From: Duran - DNR, Alicia <alicia.duran@state.co.us>  
Sent: Friday, August 23, 2019 10:12 AM  
To: Mandi Walker  
Subject: Re: [EXTERNAL] Re: FW: C W THURINGER 1-5 - 05.067.05160

| <b>Well Name:</b>        | C W THURINGER 1-5  | <b>Location:</b>        | Sec: 05              | Twn: 032N         | Rng: 006W           | UL: M |
| <b>API Number:</b>       | 05.067.05160   | <b>Footage:</b>         | 1120' FSL & 926' FWL |                   |                     |       |

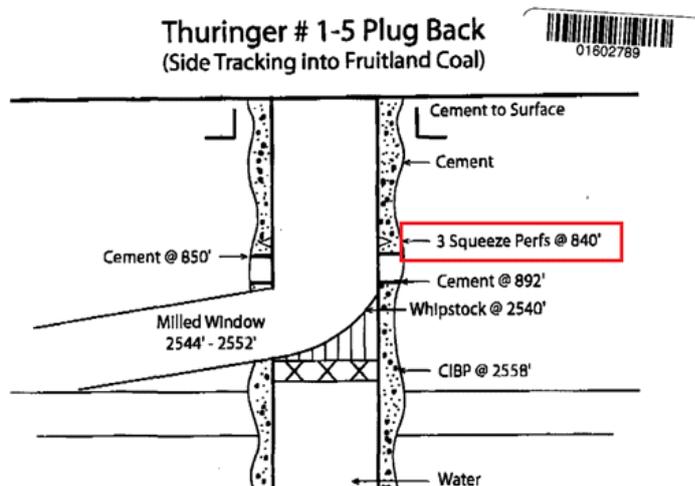
Thank you Mandi. You will need to submit a 5A for the Thuringer to document the 3 squeeze perf @ 840' (see wbd below).

Please submit the 5A for the Thuringer documenting those squeeze perfs. In addition, a sundry must be submitted to change the Thuringer to an observation (monitoring) well. Well status must be reported as AC not SI. When submitting the sundry please give a detailed description of how the well is maintained, how often it is entered and how often the pressure is checked. A Bradenhead test must be done before the sundry can be approved to keep this well in compliance. Submit by 8/30/2019.

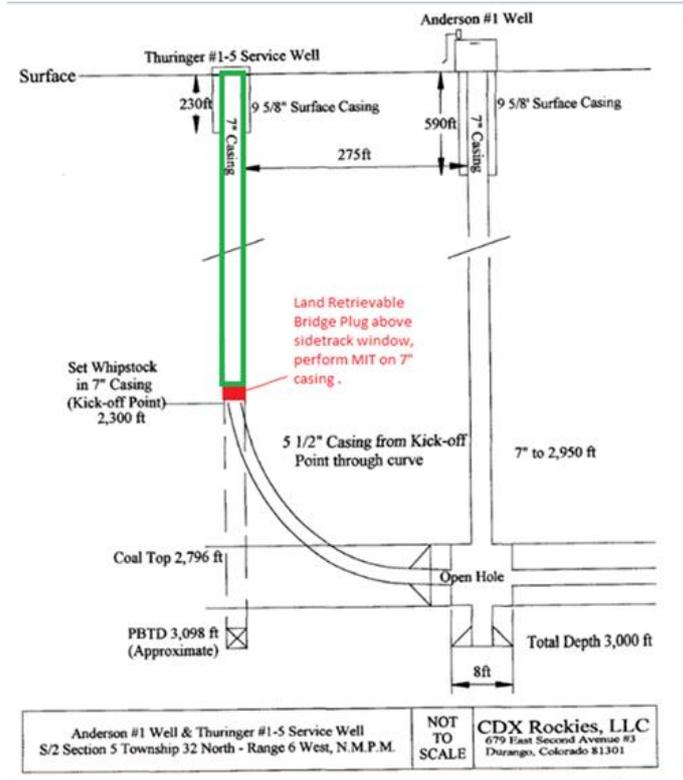
Good morning Craig,  
 This is the well that I called you about this morning that is needing an MIT. I have also attached the inspection notice that we received on this well for reference.  
 Below is the plan for conducting the MIT, our question is, will this work for the MIT?  
 Thanks!  
 Mandi

From: Joe Colley  
 Sent: Wednesday, July 31, 2019 3:52 PM  
 To: Mandi Walker <[mwalker@hilcorp.com](mailto:mwalker@hilcorp.com)>; Bob Percell <[bpercell@hilcorp.com](mailto:bpercell@hilcorp.com)>; Jason Vasquez <[jvasquez@hilcorp.com](mailto:jvasquez@hilcorp.com)>; Freddy Proctor <[fproctor@hilcorp.com](mailto:fproctor@hilcorp.com)>; Shad Brown <[shbrown@hilcorp.com](mailto:shbrown@hilcorp.com)>; John Shaw <[joshaw@hilcorp.com](mailto:joshaw@hilcorp.com)>  
 Cc: Priscilla Shorty <[pshorty@hilcorp.com](mailto:pshorty@hilcorp.com)>; Thomas Jacques <[tjacques@hilcorp.com](mailto:tjacques@hilcorp.com)>  
 Subject: RE: C W THURINGER 1-5 - INC  
 Based on the wellbore geometry, I think all we can reasonably do is set an RBP in the 7" above the sidetrack window and run the MIT on the vertically cased section shown with a green box.  
 Can we confirm that this will be acceptable prior to undertaking the effort?

Your plan is acceptable as long as the RBP is set within 100' of the liner top.

However, COGCC has no record of the liner. Or are there multiple liners? We have directional data in our system indicating 3 horizontal wellbores with the suffix -00, -01, and -02. I assume that data came from the directional survey in our well file (doc #1602790).
